PART VI | COMPARISON DRAWINGS

107 HIGH STREET, LINDFIELD, HAYWARDS HEATH, RH16 2HR

**PART VII | PROPOSED REGULARISATION
OF SCHEME**

PROPOSED REGULARISATION OF SCHEME
SUMMARY

COMPARISON - SITE PLAN REV A. 1:300@A3

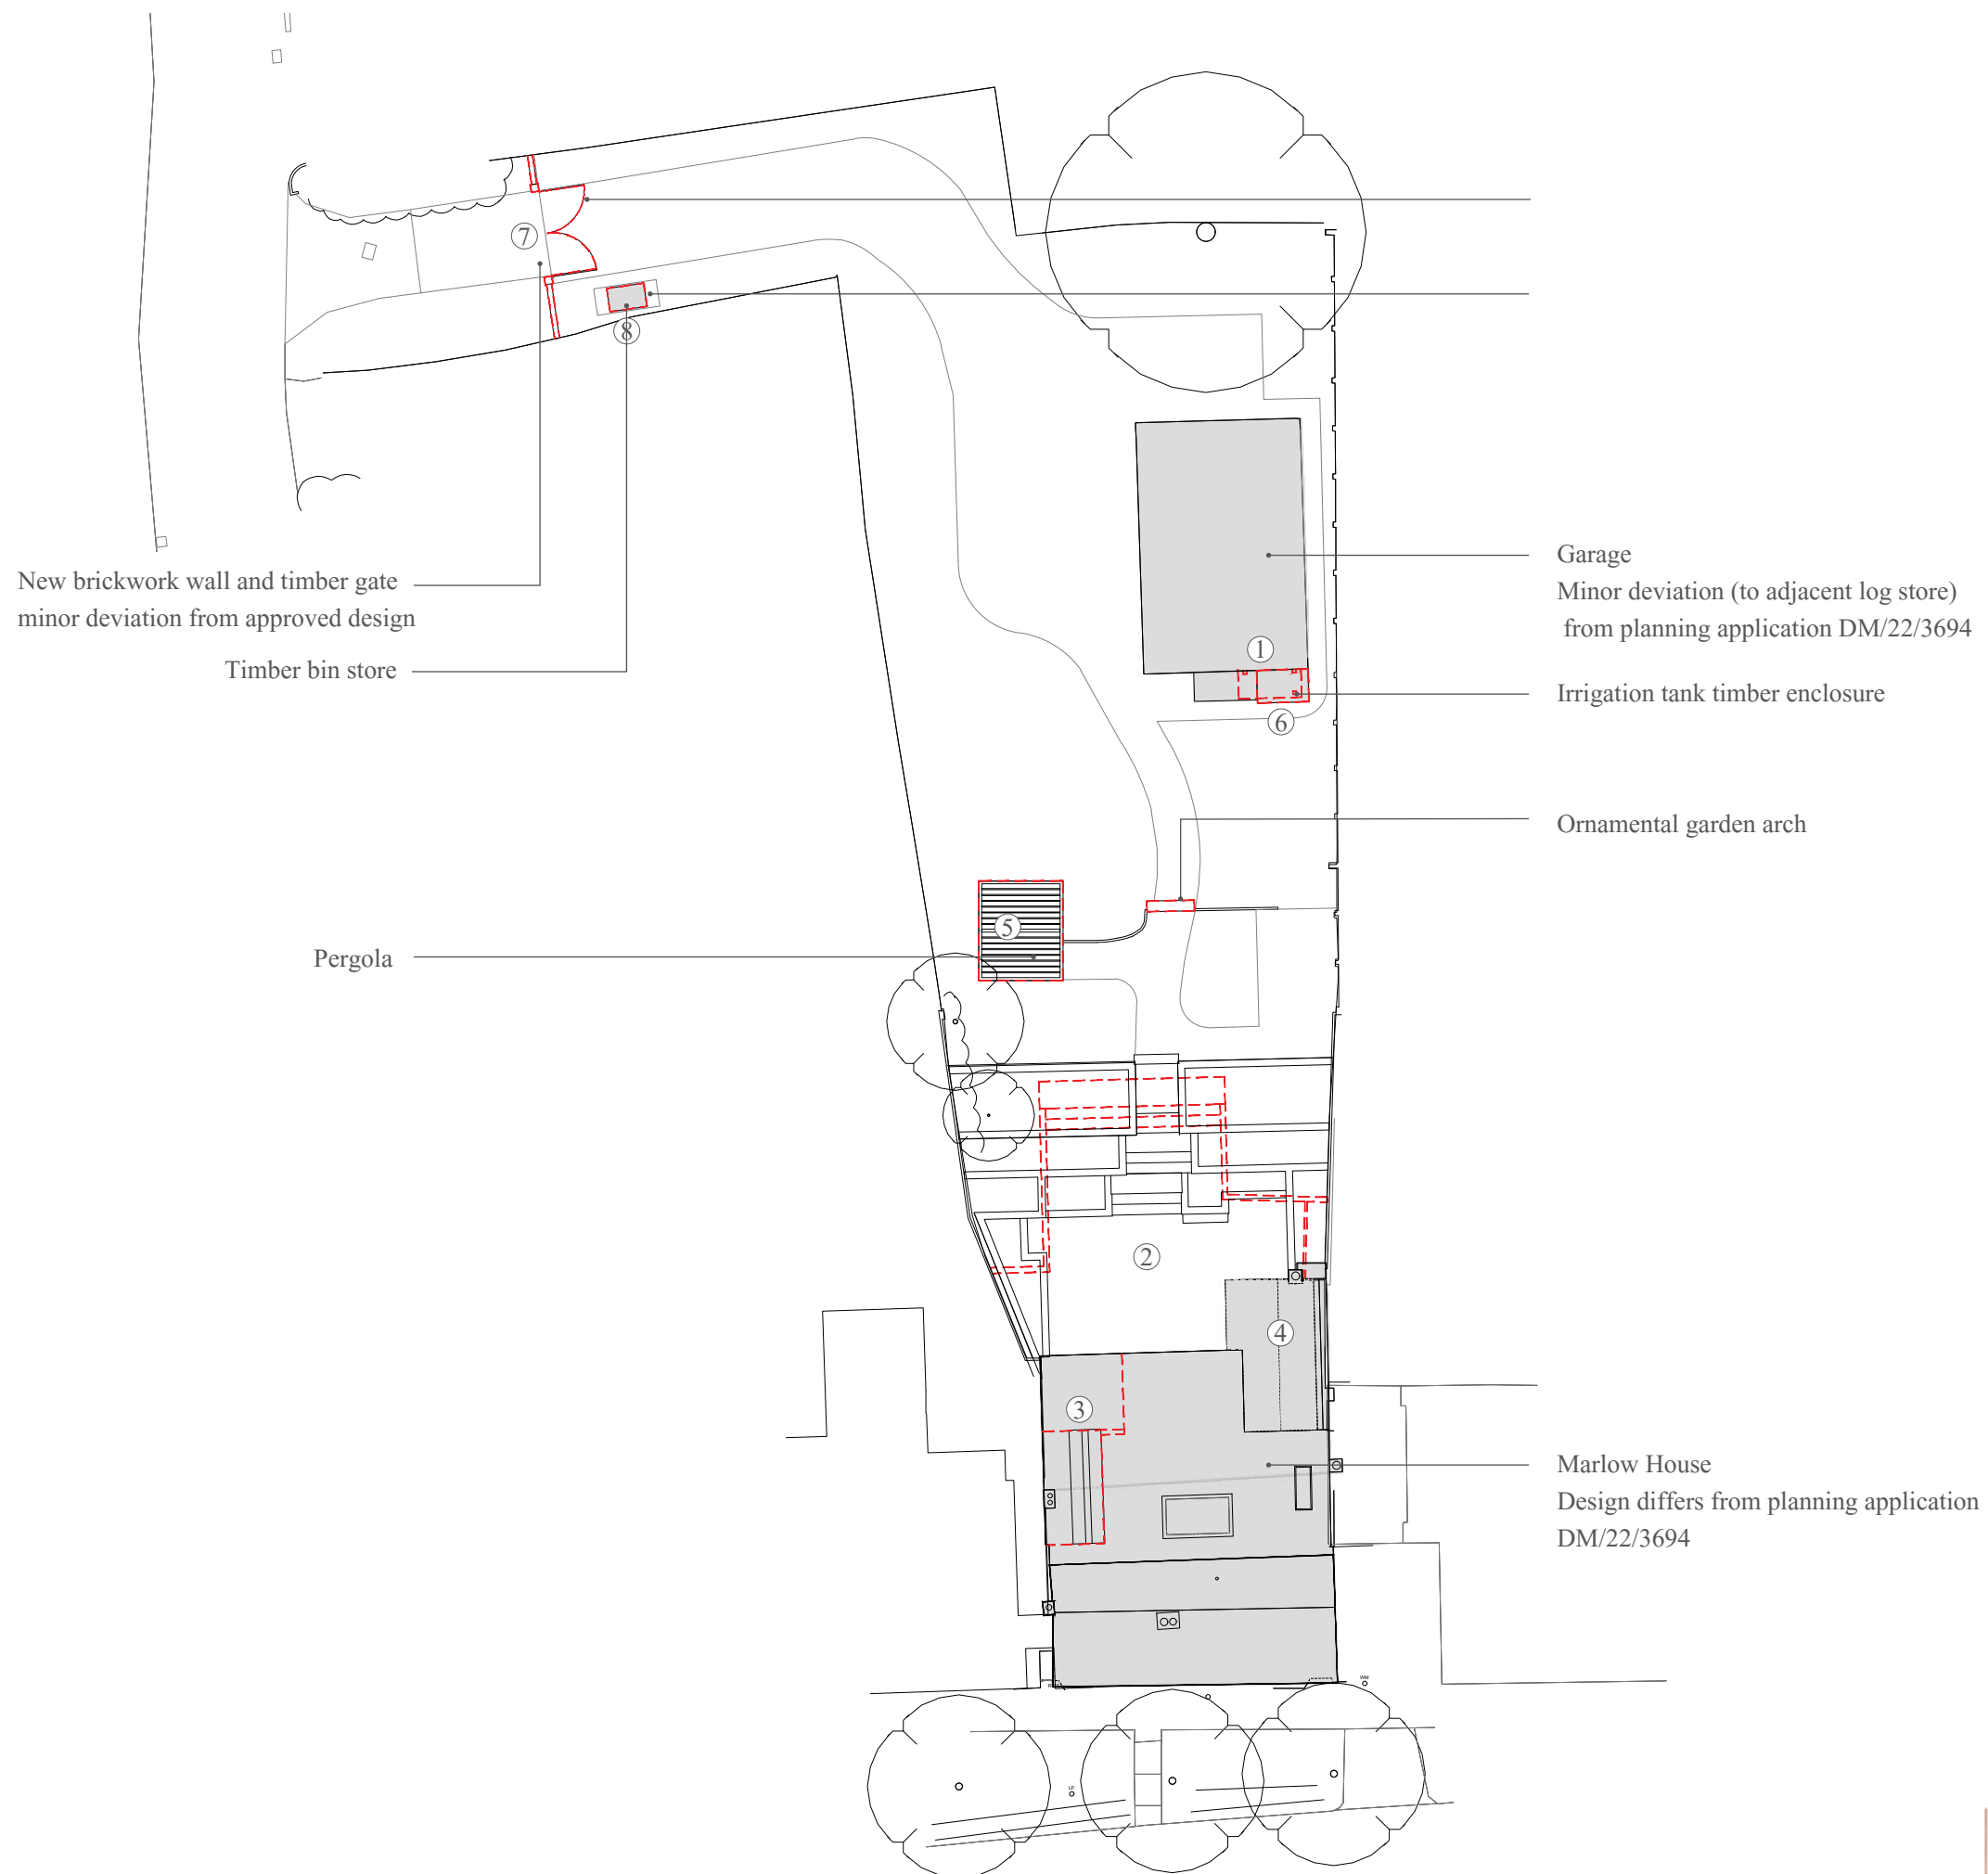
1. Garage design deviates from approved design
2. Landscape deviates from approved design
3. Rear extension spans across full width and deviates from approved design
4. Historic bake house re-constructed following its collapse during strip-out.
5. Pergola - no planning permission
6. Irrigation tank timber enclosure, no planning permission
7. Brickwork gate and timber gate deviates from approved design
8. Timber bin store, no planning permission

COMPARISON - BASEMENT FLOOR PLAN REV A. 1:100@A3

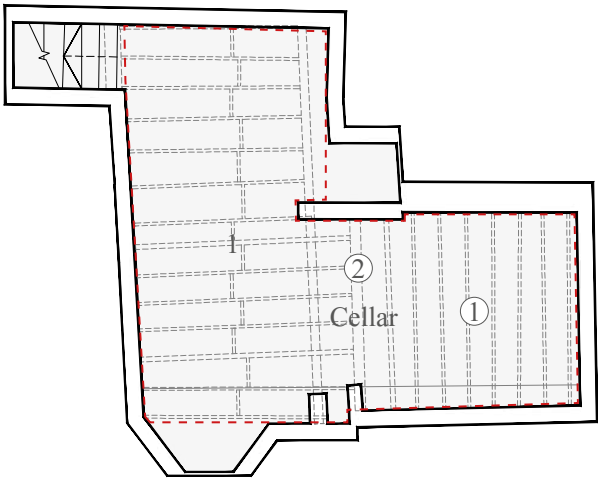
- 1. Existing joists replaced with new
- 2. Steel railway member replaced with steel beam

COMPARISON - GROUND FLOOR PLAN REV A. 1:100@A3

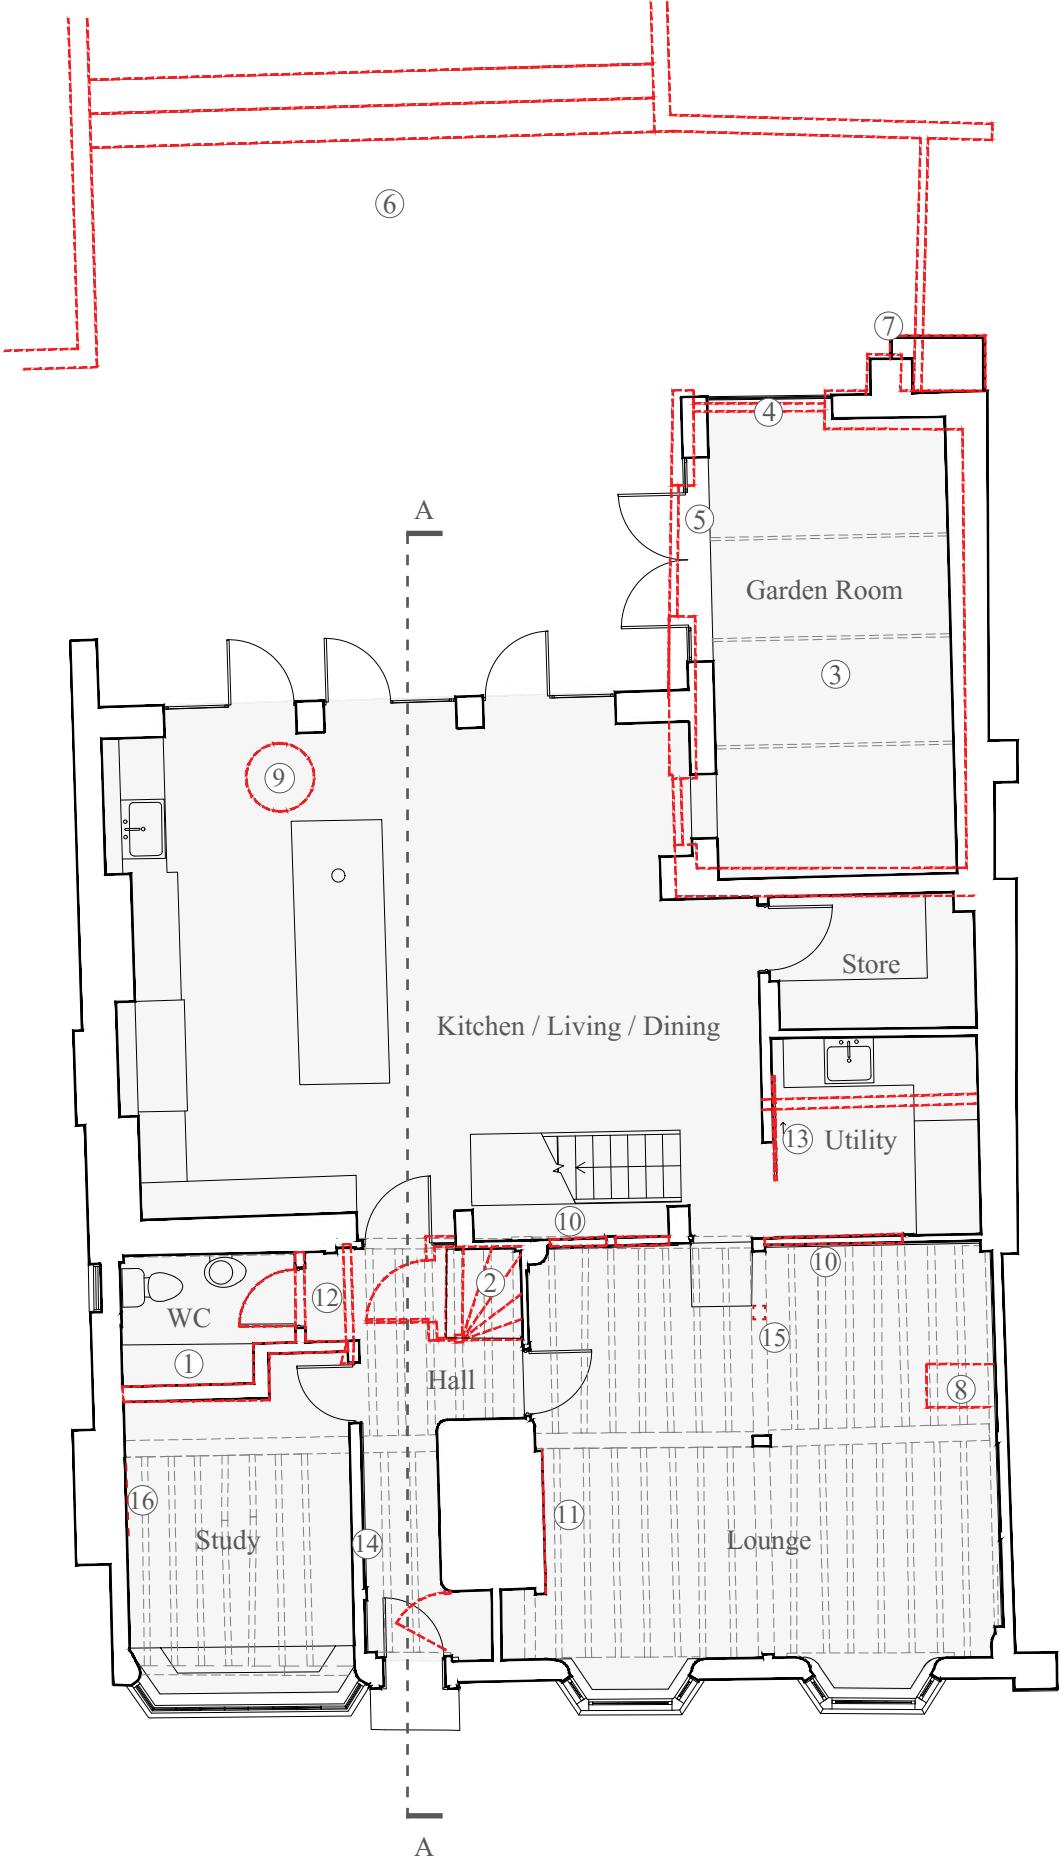
- 1. Change of layout - WC added
- 2. Existing staircase (linking ground, first and second floor) removed
- 3. Historic bake house re-constructed following its collapse during strip-out.

- 4. Window of different design
- 5. Doors of different design
- 6. Landscape of different design
- 7. AC AHU louvred timber enclosure - matching timber of new extension

- 8. Existing chimney stack removed
- 9. Glass covering of historic well (discovered during construction works)
- 10. Removal of 1990s internal casement windows to box framing of 15th century west wall, openings filled in with timber stud framing, wood wool boards and lime plaster

- 11. Re-facing of main chimney breast to ground and first floor rooms in reclaimed brick in hydraulic lime mortar incorporating new hearths
- 12. Removal of timber stud wall with stone veneered nogging at ground level to create a reveal / recessed entrance to WC is proposed as implemented.

- 13. Sliding door partition to wine cellar / utility room,
- 14. Timber cladding to evoke timber framing to main entrance passage on walls
- 15. Historic door jamb removed

- 16. Electric fireplace installed in the existing fireplace opening

COMPARISON - FIRST FLOOR PLAN REV A. 1:100@A3

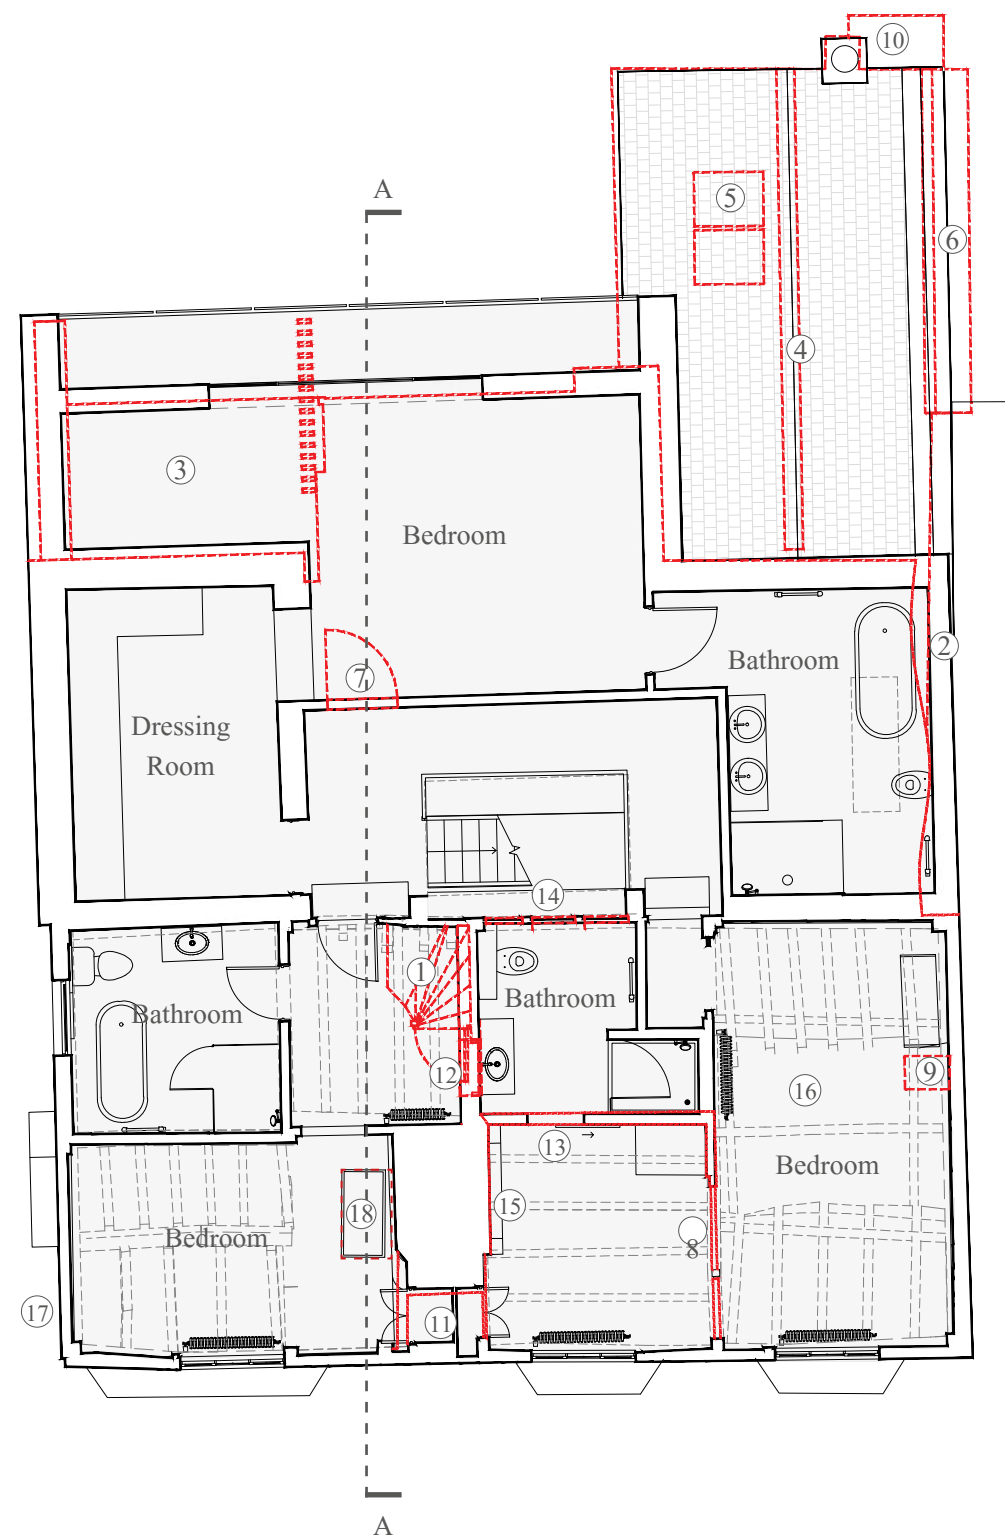
1. Existing joinery and staircase (linking ground, first and second floor) removed
2. Flat roof extension above bathroom
3. Rear extension extended - spanning full width, concealing the historic gable

4. Historic bake house re-constructed following its collapse during strip-out.
5. Rooflights omitted (2no)
6. Gutter design deviates from approved- parapet wall and secret gutter

7. Existing door opening blocked up
8. Modern plaster infill panel removed, original oak frame retained
9. Existing chimney stack removed
10. AC AHU louvred timber enclosure - matching timber of new extension

11. Fitted back to back wardrobe with new joinery installed within the existing niche
12. Existing doorway blocked up, additional wall build-up
13. New partition and sliding door to create bathroom

14. Removal of 1990s internal casement windows to box framing of 15th century west wall, openings filled in with timber stud framing, wood wool boards and lime plaster

15. Re-facing of main chimney breast to ground and first floor rooms in reclaimed brick in hydraulic lime mortar incorporating new hearths
16. Overlaid seasoned oak flooring to first floor rooms overlaying original floorboards (retained in situ)

17. Timber weatherboarding not continued to ground level*
18. Attic access hatch

COMPARISON - SECOND FLOOR PLAN REV A. 1:100@A3

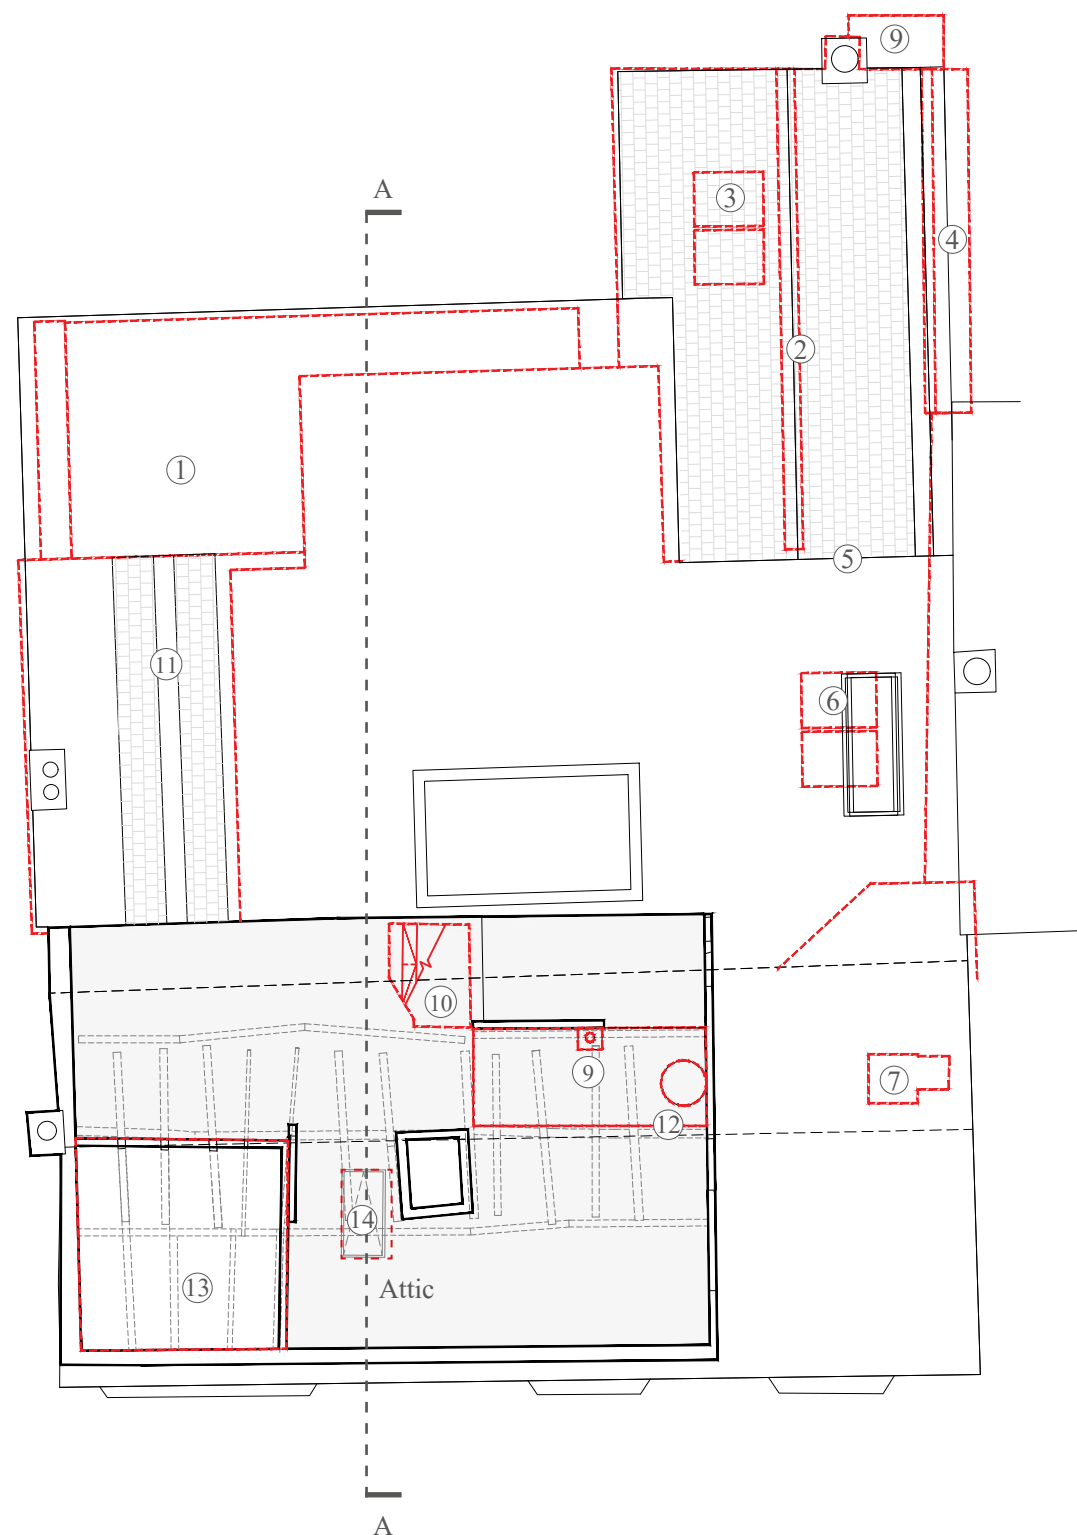
1. Rear extension extended - spanning full width, concealing the historic gable
2. Historic bake house re-constructed following its collapse during strip-out.
3. Rooflights omitted (2no)
4. Gutter design deviates from approved- parapet wall and secret gutter
5. No step between roof planes
6. Single rooflight instead of two
7. Existing chimney removed
8. AC AHU louvred timber enclosure - matching timber of new extension
9. Boiler and flue installed
10. Existing staircase (linking ground, first and second floor) removed
11. Historic gable partially visible above new flat roof
12. Water tank installed
13. Vaulted ceiling above bedroom
14. Attic access hatch
